From: Steve Hamann <shamann@hamann.com>
Sent: Wednesday, July 09, 2014 10:35 AM
To: Greg Minikel
Subject: FW: Americollect
Attachments: AMERIC_2014_REV_DRV_2.pdf

Subject: Americollect

Americollect is looking at a substantial expansion and new parking lot. The new lot would access Fessler Drive east of the east end of the concrete on the gravel. Do they need to extend the concrete or place asphalt to a point on the east side of their drive?

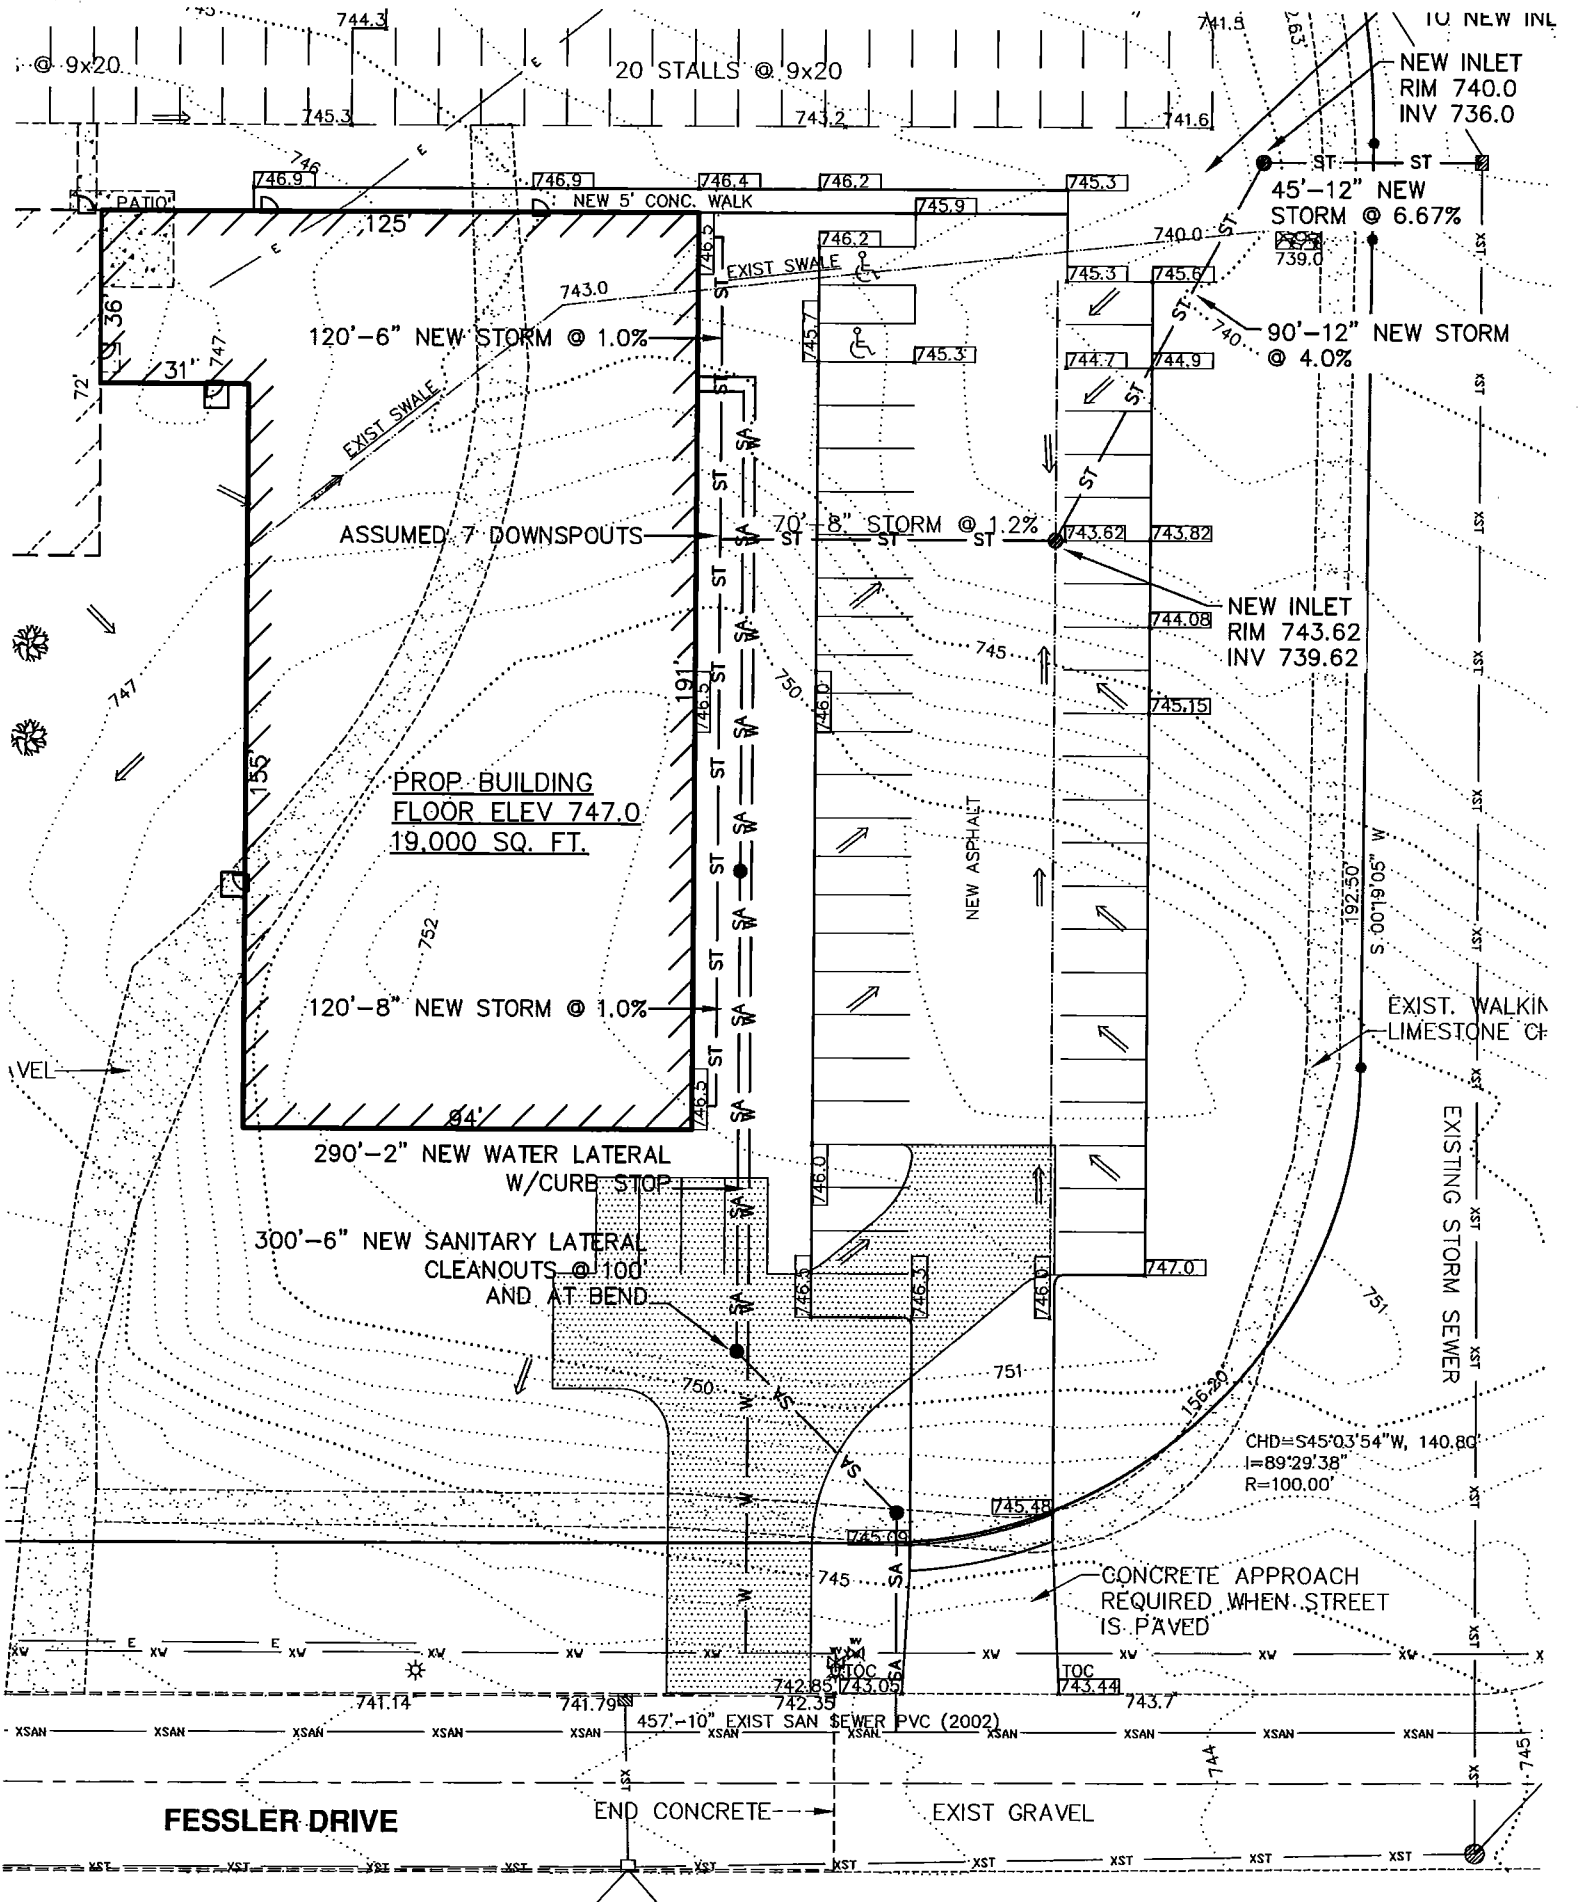
Good afternoon, In our intial design we show an entrance/exit to the new parking lot unto Fessler Dr. After preliminary review by the City Engineer they are concerned that if the concrete pavement is not extended to the east past the new entrance/exit now, you will not be able to use it when paving in the future. Options #1 Extend the pavement now (see approx cost). #2 Create a temp road/drive between the new lot and the lot to the north while paving is done in the future. #3 Put a curly Q in entrance/exit approach (see drawing) and have a curb cut it enter onto the existing pavement. Your thoughts.

Here is a drawing that moves the drive over to the concrete. There is a hydrant at the end of the concrete that we need to go around. This layout eliminates one stall. If we eliminated a few more stalls on the west we could make the curve look nicer.

I am torn on this one. The future planning part of my thinking is to pave the 50 feet plus or minus in concrete now, so that they do not have any disruption to access at a later date when it is paved. Paving the streets with concrete has been the past practice for all of the development in the I-TEC area. In the past, TIF funding was also used for the original construction of Fessler Dr. My recommendation would be to pave it with concrete as part of the new development/expansion.

Looking at a quick cost estimate to pave the 50 ft. long by 37 ft. wide concrete pavement would be about 206 SY at say \$50/SY would be a total of \$10,300. How much did you have for placing 3 inches of asphalt in the roadway?? I would estimate the asphalt to be about \$4,000 - \$5,000.

At a minimum, the roadway and driveway approach shall be asphalt pavement.

CONCRETE APPROACH
REQUIRED WHEN STREET
IS PAVED

I looked at another option for the entrance that gives a little better traffic flow. Adds pavement to the project.
Paul
